**CITY OF SAN ANGELO
SAN ANGELO LANDFILL
TOM GREEN COUNTY, TEXAS
TCEQ PERMIT NO. MSW 79**

**SITE DEVELOPMENT PLAN
AND
PERMIT MODIFICATIONS
(THROUGH DECEMBER 2013)**

Modification to Municipal Solid Waste Permit No. 79 San Angelo Landfill

MODIFICATION TO MUNICIPAL SOLID WASTE PERMIT NO. 79 CITY OF SAN ANGELO LANDFILL

PERMITTED CROSS SECTION	
SAN ANGELO LANDFILL TCEQ PERMIT NO. MSW 79 10 FOOT HEIGHT INCREASE	
	BIGGS & MATHEWS ENVIRONMENTAL CONSULTING ENGINEERS MANSFIELD DALLAS • WICHITA FALLS 817-563-1144
DSN. ALN DATE : 02/08 DWN. SRC SCALE : GRAPHIC CHK. ALN DWG : FinalGrading-Sect.dwg	DRAWING 94-03D

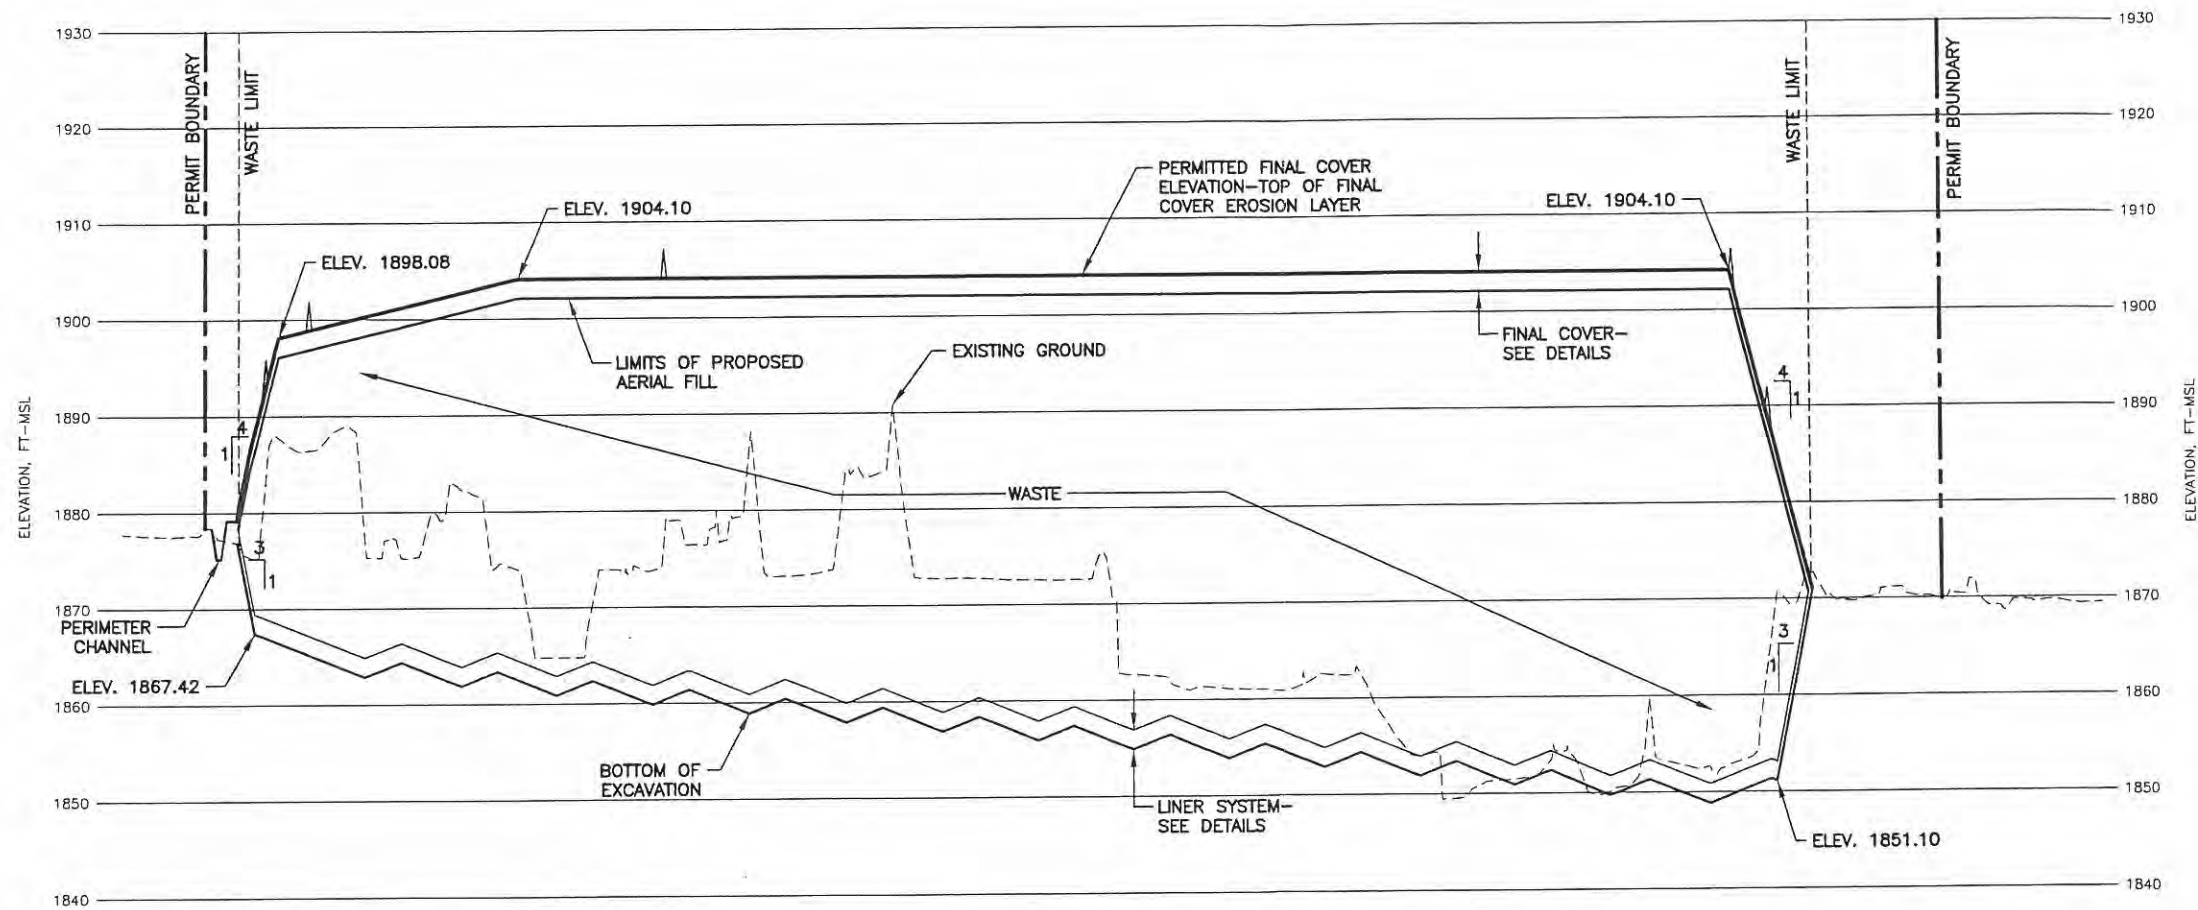
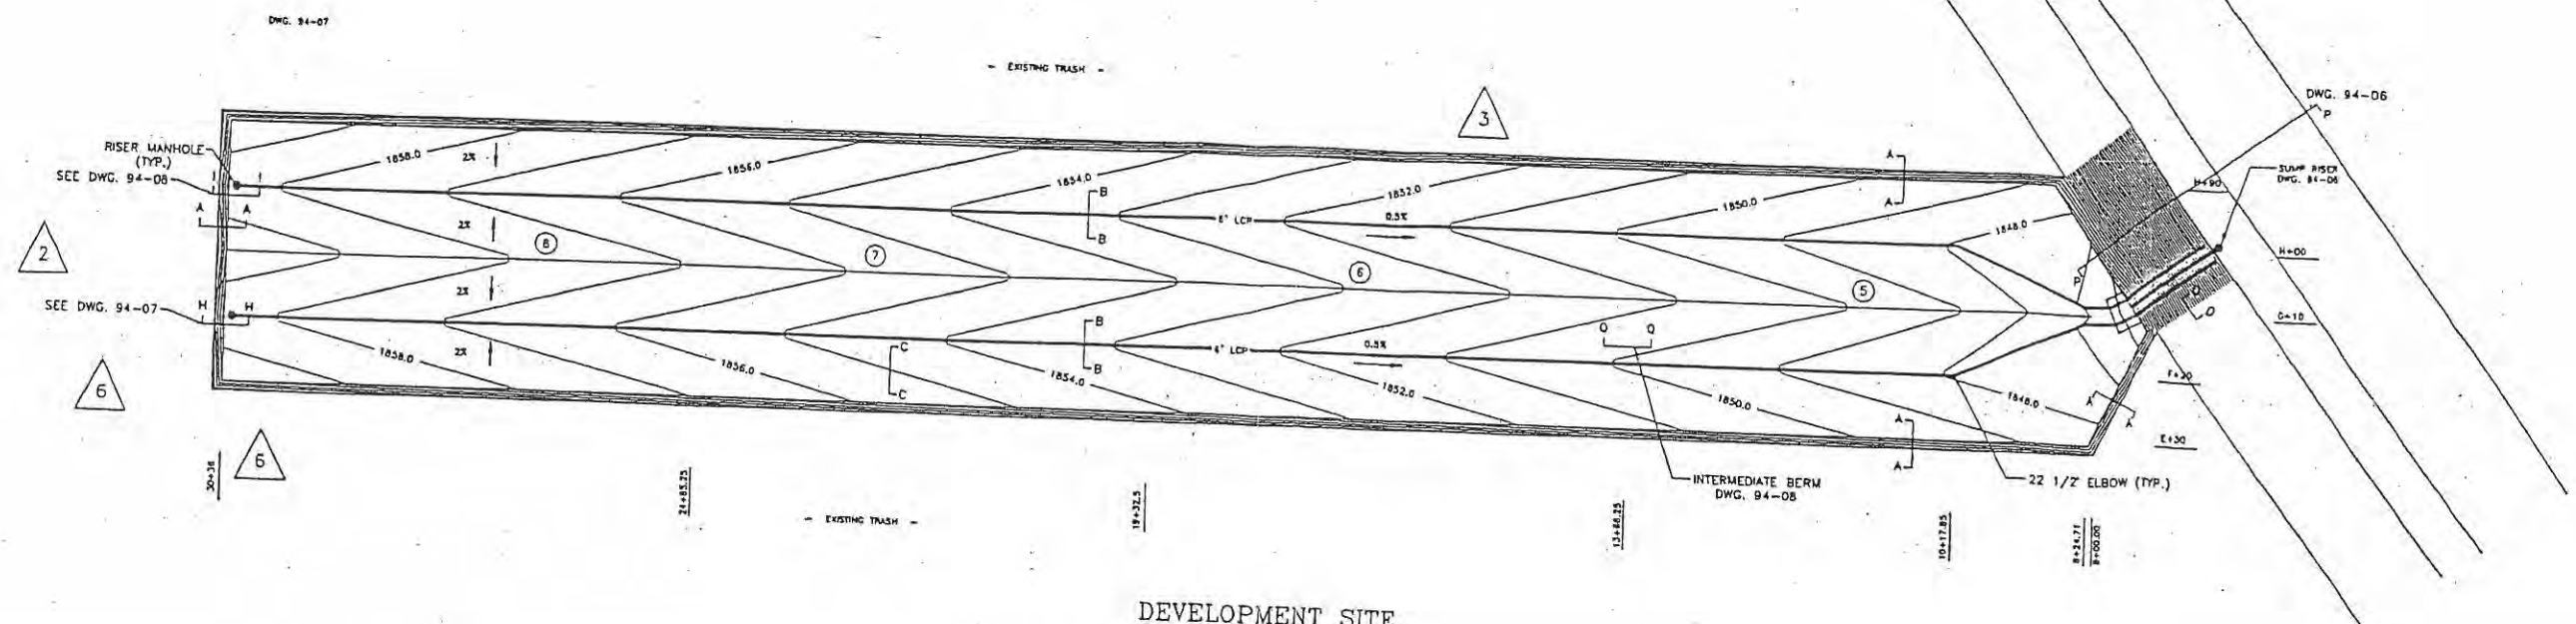
Modification of the Site Development Plan to revise the final contours and increase the maximum height of the landfill by 10 feet, from 1920 feet above mean sea level (ft-msl) to 1930 ft-msl, to improve surface water drainage and to reduce the limits of waste area north of the gas pipeline from 41.5 acres to 31.9 acres, creating a reduced total waste disposal footprint of 225.2 acres.

Attachment 2, Drawings 94-03B, 94-03C, 94-03-D, 94-08A are added new.

DRAWING
94-05

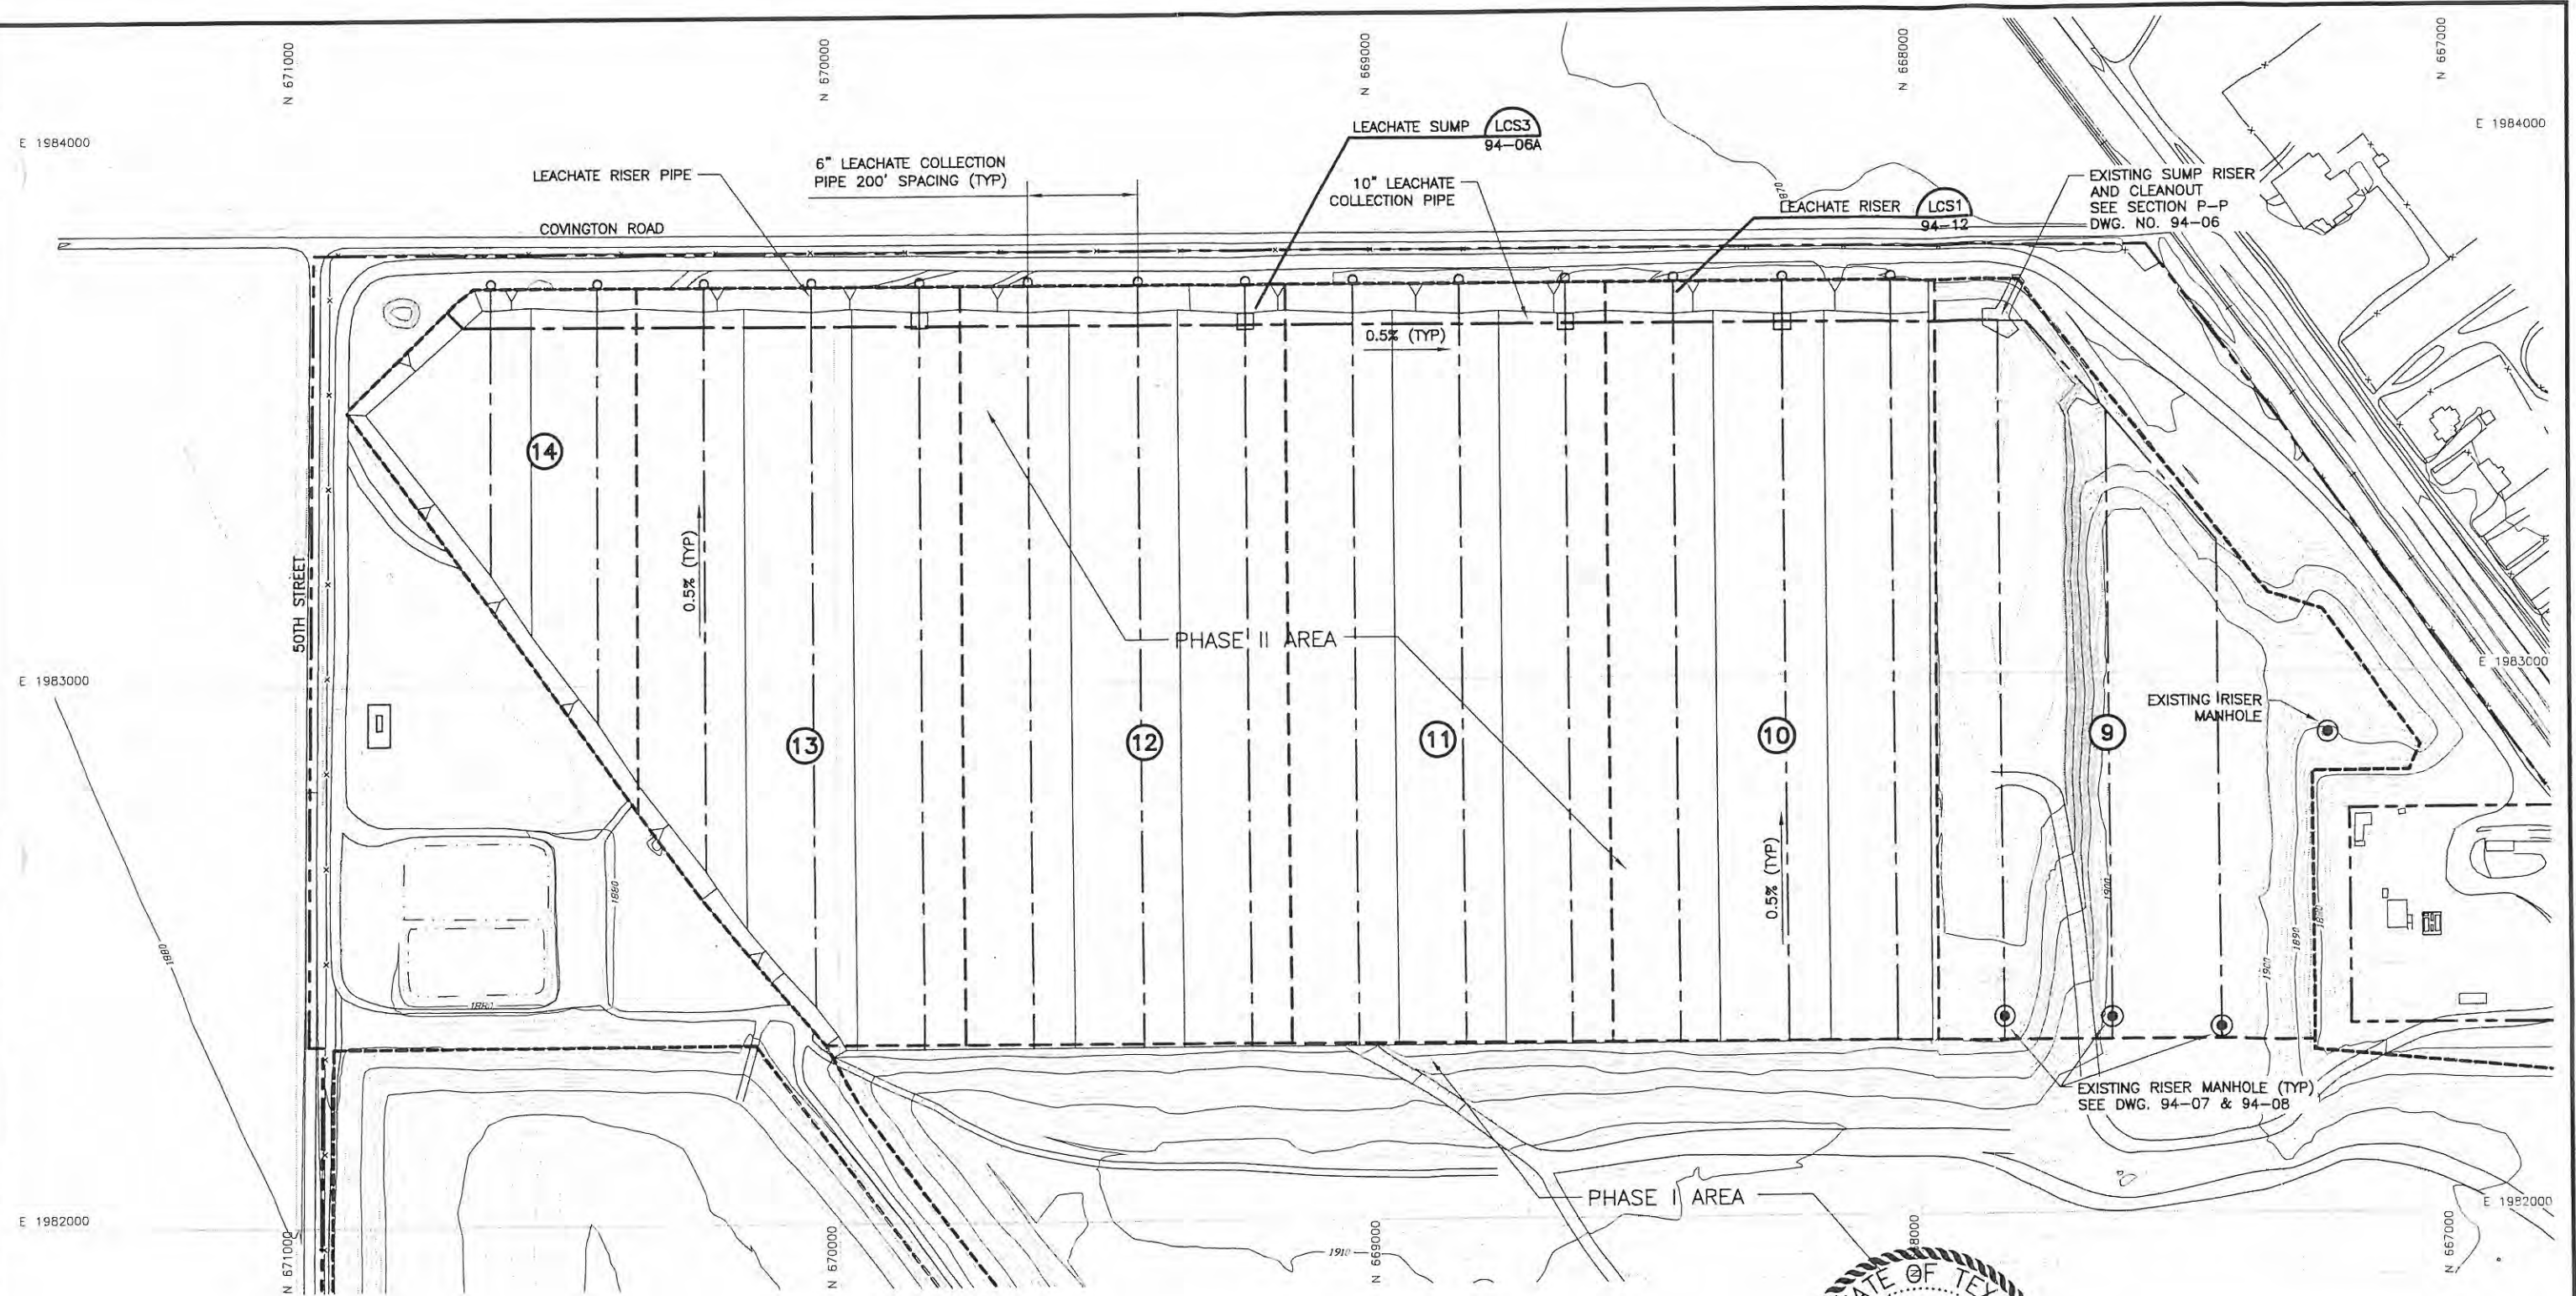
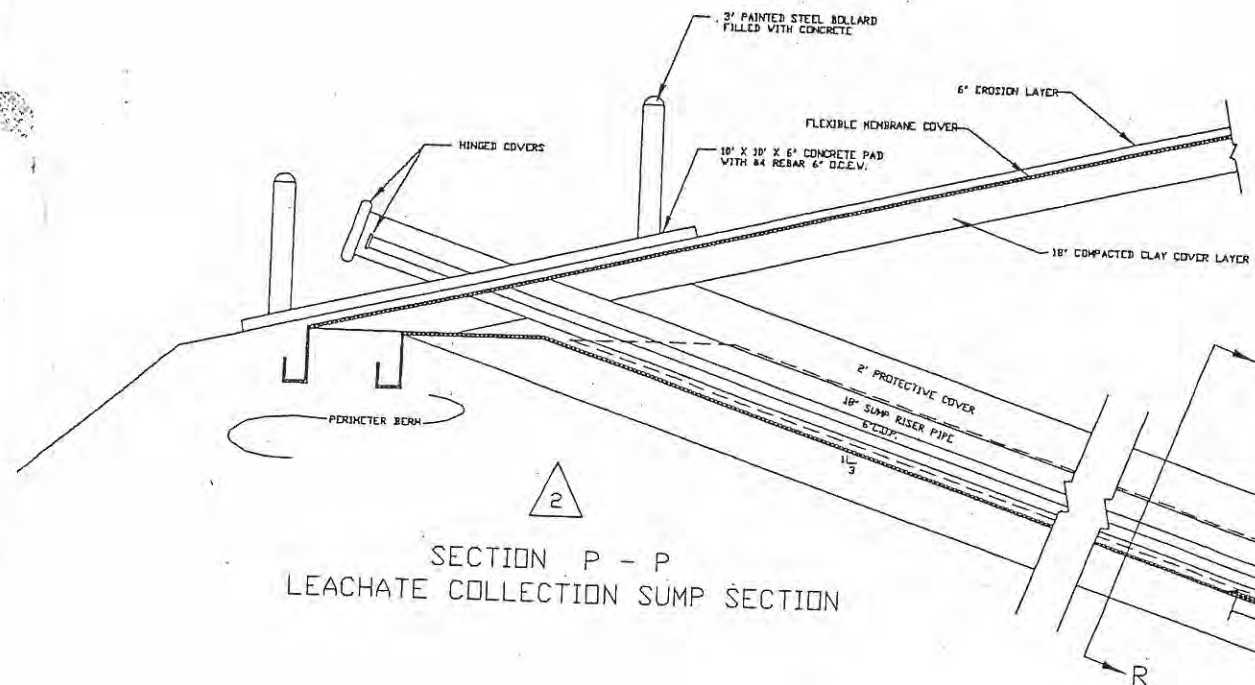
We have reviewed your application for a municipal solid waste permit modification received February 27, 2008, requesting to install additional leachate collection sumps in the Phase II Area. The information presented is technically sufficient for a municipal solid waste permit modification.

1. Part III, Site Development Plan, Attachment 2, Title Page.
2. Part III, Site Development Plan, Attachment 2, Table of Contents, Page ii.
3. Part III, Site Development Plan Drawing Nos. 94-05, 94-06A, 94-09, 94-09A, 94-10, 94-10A, 94-11.
4. Part III, Site Development Plan, Attachment 3, Appendix 3A, Attachments 3A.1, 3A.6, and 3A.7.
5. Part III, Site Development Plan, Attachment 10, Complete Replacement.

REVISIONS					
REV	DATE	DESCRIPTION	DWN BY	DES BY	CHK BY
4	02/08	ADDED SUMPS	WCM	ALN	ALN
3	01/07	ADDED RISER PIPE CLEAN OUT	RMP	SAN	KJW
2	12/07/01	ADDED 10" LEACHATE COLLECTION PIPE	-	-	-
1	12/07/01	DELETED CLEAN OUT & ADDED RISER M.H.	-	-	-

LEACHATE COLECTION PLAN RISER PIPE DETAILS			
SAN ANGELO LANDFILL PERMIT MODIFICATION			
		BIGGS & MATHEWS ENVIRONMENTAL CONSULTING ENGINEERS MANFIELD DALLAS • WICHITA FALLS 817-563-1144	
DSN. SAN	DATE : 01/07	APPENDIX	
DWN. RMP	SCALE : GRAPHIC	94-12	
CHK. KJW	DWG : LinerDetails.dwg

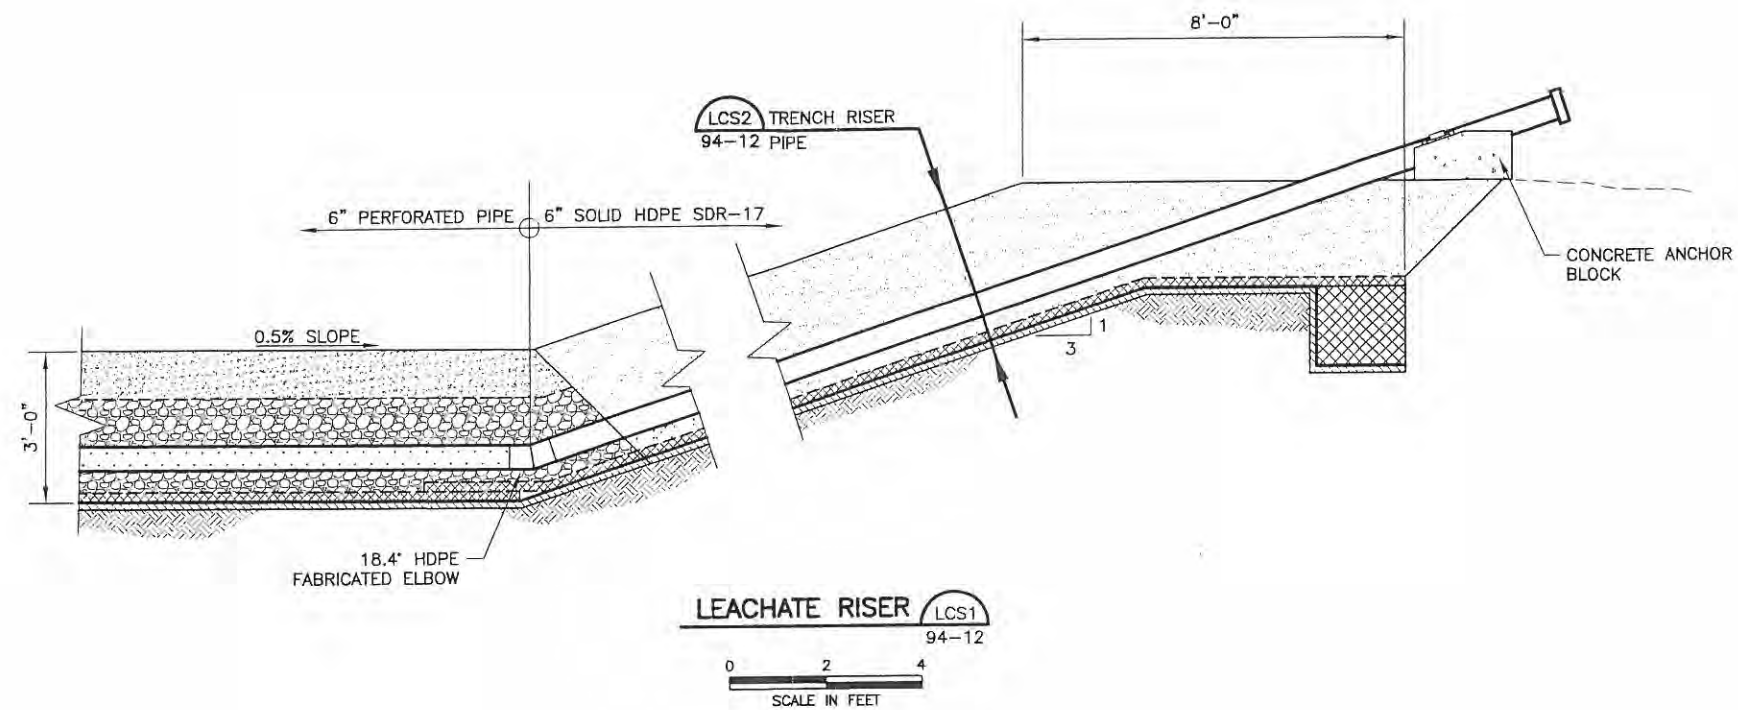
The modification authorizes the use of a leachate sidewall riser pipe for leachate collection pipe cleanout in each cell, instead of the leachate manhole riser.

Attachment 2, Site Development Plan
Attachment 10, Leachate Contaminated Water Plan
Appendix C, Representative Leachate Collection System Cleanout Information
Appendix F, Leachate Collection System Details
